Georgia Institute of Technology

MEMORANDUM

To: R.A. Karam
From: B. Copcutt *B Copcutt*
Subject: Replacement of moving air particulate monitor detector

TITLE: G.M. TUBE REPLACEMENT ON MAP1

**MODEL 44-7
END WINDOW GEIGER-MUELLER PROBE**

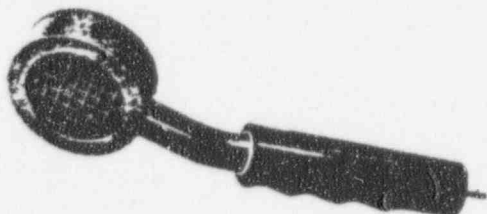
The detector was replaced with another thin end window type GM tube. Exact specifications for the old detector were not available. The old detector was manufactured by Nuclear Chicago, a company that has long been out of business. The new tube, a Ludlum Model 44-7 (see attached brochure) has identical end window dimensions and otherwise appears comparable to the old. The protective wire screen was removed before the tube was installed in the MAP1 system. A full annual calibration was carried out on the replacement detector and it was observed that the new system has an increased efficiency compared to the old (approximately 70% greater response for Ra-226 and 50% greater for Co-60).
